Illustrated Parts List - IPL Update

H556

1. Filter holder

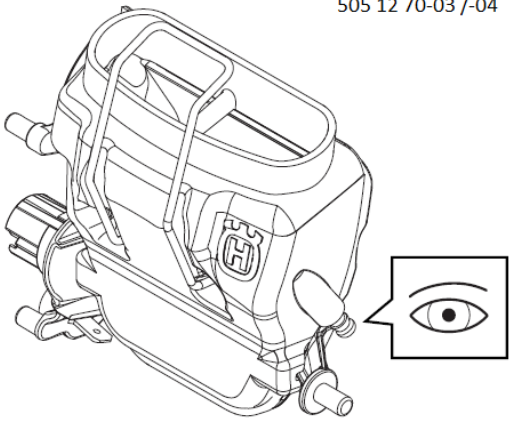
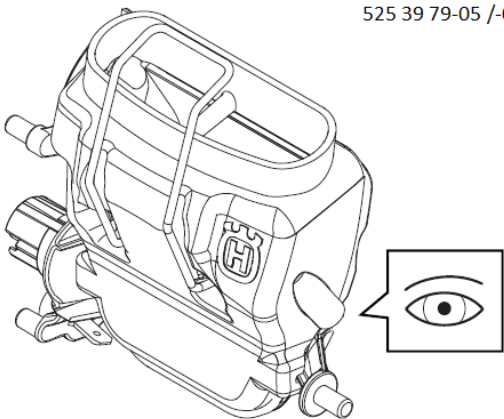
1. A new Filter holder, assy: 525 39 79-05 (standard) has been introduced. No nipple, hole removed to improve the startability.
2. A new Hose kit 589 35 71-01 replace the Hose 587 64 54-02. The new kit can be used for both new and old models regardless of which generation of filter holder the user have.
3. A new Hose 587 64 54-04 added for the new filter holders without nipple.
